Docket No. 50-312

IE Bulletin No. 80-20

FAILURES OF WESTINGHOUSE TYPE W-2 SPRING RETURN TO NEUTRAL CONTROL SWITCHES

FIGURE 1

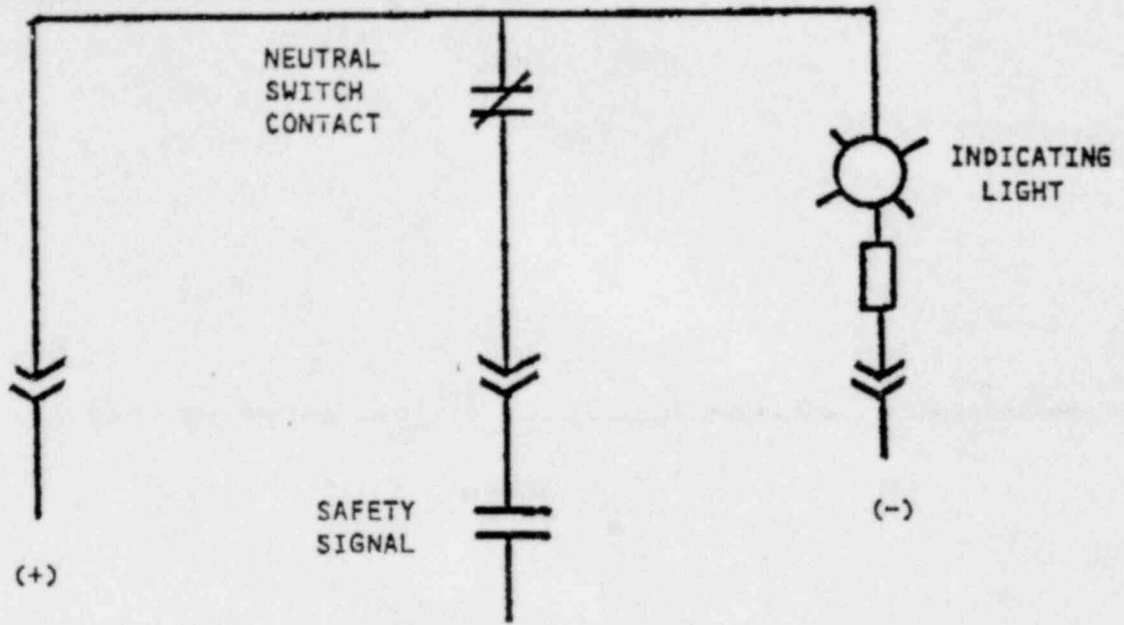
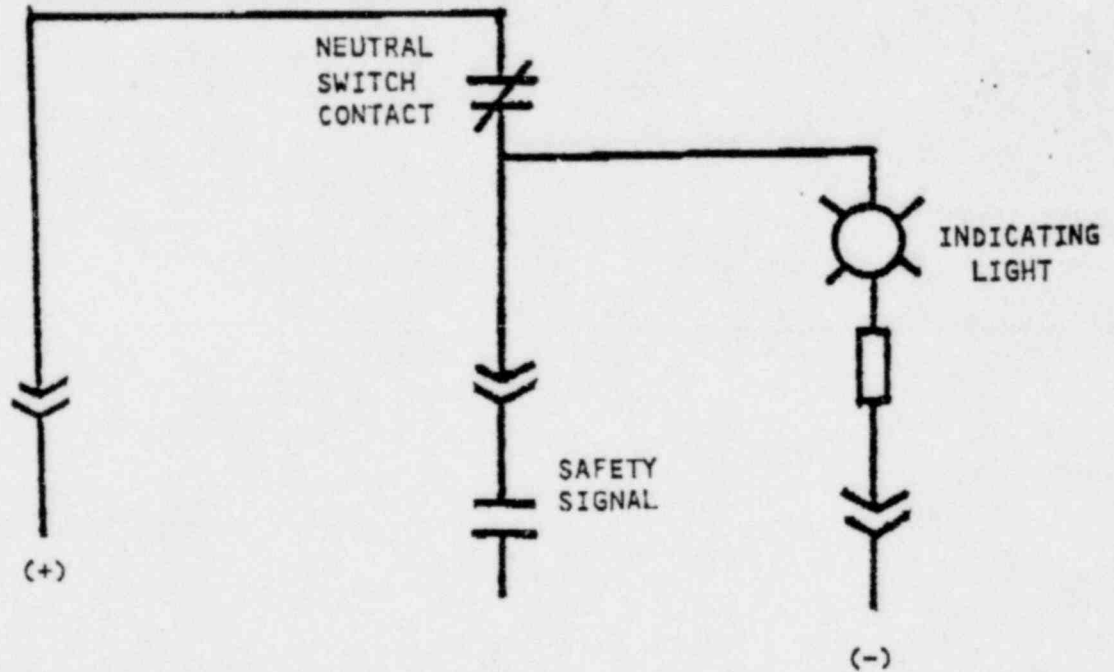
A review of this matter by Westinghouse led to the issuance of NSD Technical Bulletin No. NSD-TB-80-9 to the utility owners of all Westinghouse operating plants. The recommendations contained in the Westinghouse technical bulletin include: (i) testing the neutral position contacts of the subject W-2 switches for continuity, and (ii) rewiring of the indicating light circuit to permit the early detection of a neutral contact failure as shown in Figure 1.

Depending on how the indicating light circuit is wired, loss of continuity thru the neutral position contact of a W-2 switch could remain undetected until the equipment associated with the switch were called upon to operate. Since such a failure would be equivalent to by-passing the system associated with the switch, consideration should be given to rewiring the switches used in safety-related applications as shown in Figure 1. Such rewiring would provide an acceptable means for detecting contact failure, provided the indicating light is in the control room and readily visible by the operator. If the indicating light is not so located, consideration should be given to annunciating the neutral position contact failures at the control room to alert the operator of the inoperable status of a safety-related system. In addition, consideration should be given to adding redundant contacts to the W-2 switches or to replacing the W-2 switches with others having a more positive contact wiping action.

3. Licensees of operating plants and holders of construction permits shall describe the longer term corrective measures planned and the date by which such measures will be implemented by actual installation or by design change, as appropriate. As a minimum, the longer term corrective measures should include rewiring the indicating light as shown in Figure 1 provided the light is readily visible to the control room operator. If not, failures of the neutral position contacts should be annunciated in the control room.

REWIRING OF INDICATING LIGHT CIRCUIT OF W-2 SWITCHES  
AS RECOMMENDED BY WESTINGHOUSE TECHNICAL BULLETIN NSD-TB-80-9
